From: David Campbell
To: Greg Graham
CC: 'Brad Herndon'
Sent: 4/10/2012 5:05:17 PM
Subject: FW: Driftwood Volume Checks
Attachments: Driftwood Calcs Checks.pdf; DriftwoodStormwater2-29-12.pdf

From: Shortt, Christopher [mailto:Christopher.Shortt@dep.state.fl.us]
Sent: Monday, March 19, 2012 8:53 AM
To: dcampbell214@comcast.net
Subject: Driftwood Volume Checks

DRIFTWOOD ESTATES-PHASE II

EVALUATION OF OUTFALL CONTROL STRUCTURES BASED ON AS-BUILT CONDITIONS

Drainage Area #2 – Outfall structure at Lake #9

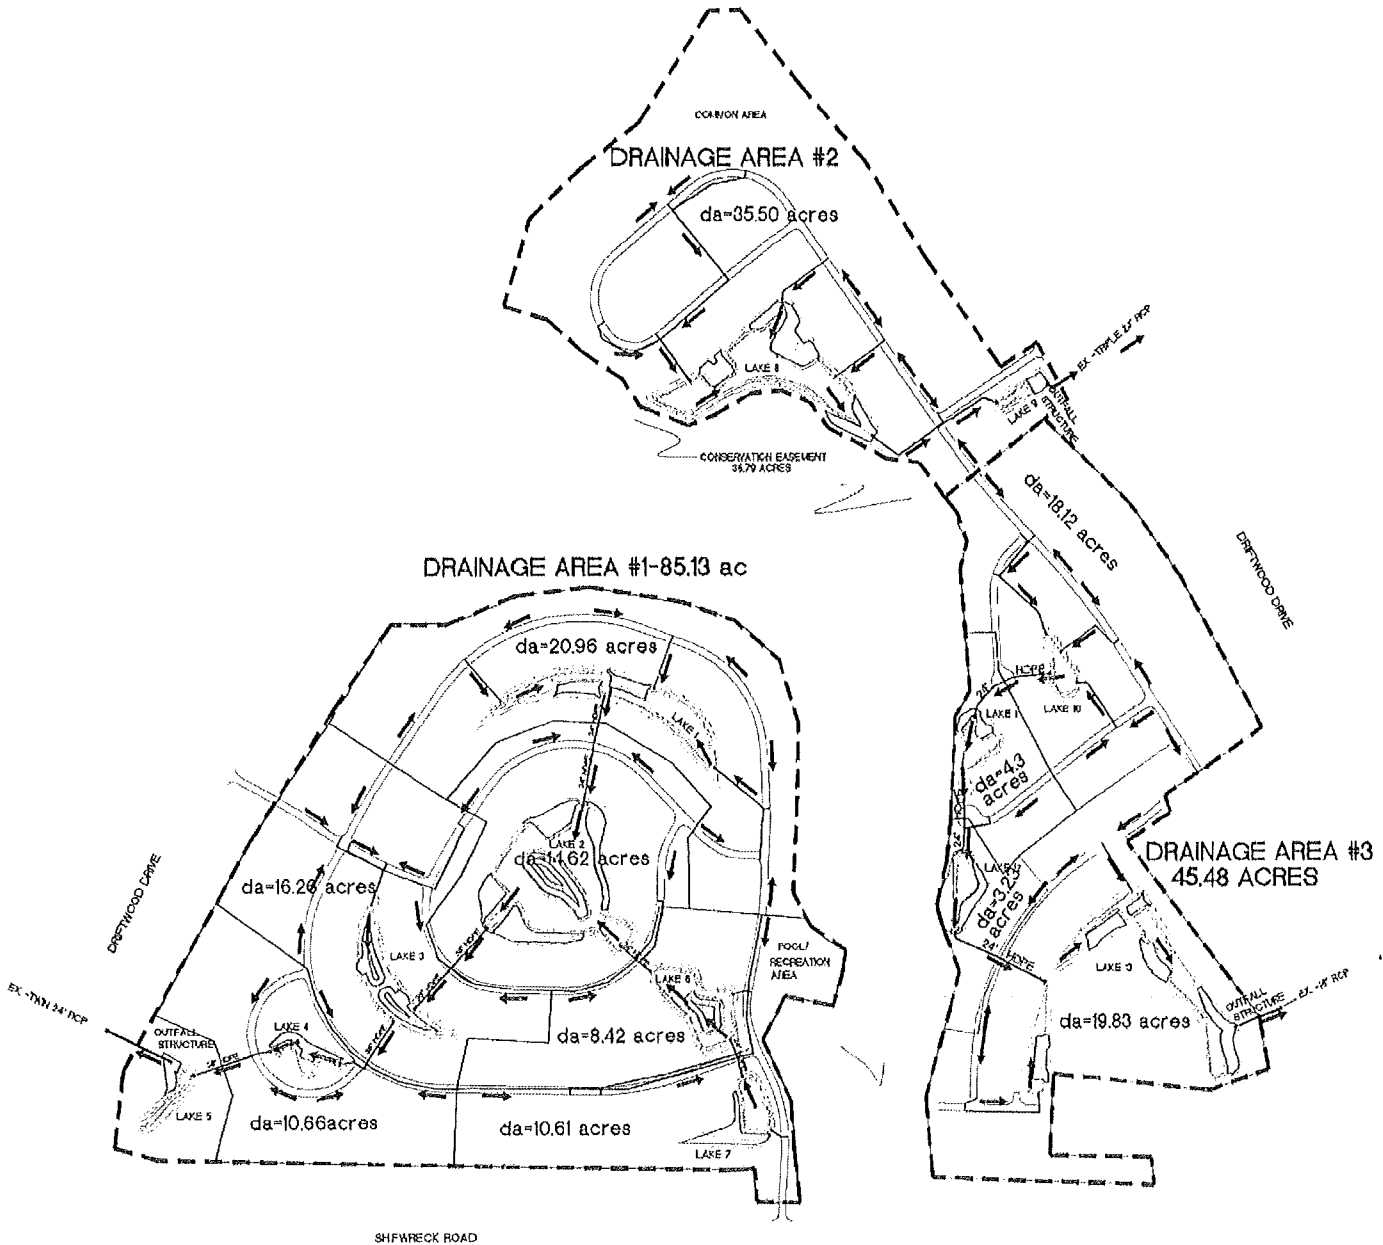
1. Because the drawdown orifice was adjusted from the design elevation of 4.5 to the as-built elevation of 4.2 lowering the permanent pool elevation 0.30 ft, the discharge weir elevation shall be adjusted from the as-built elevation of approximately 5.0 to a new elevation of 5.17. This will ensure the 1" retention volume requirement is met.
2. The as-built permanent pool volume remains well above the required volume.
3. The drawdown orifice as-built will function according to design.
4. Adjust each skimmer according to the proposed weir elevation.
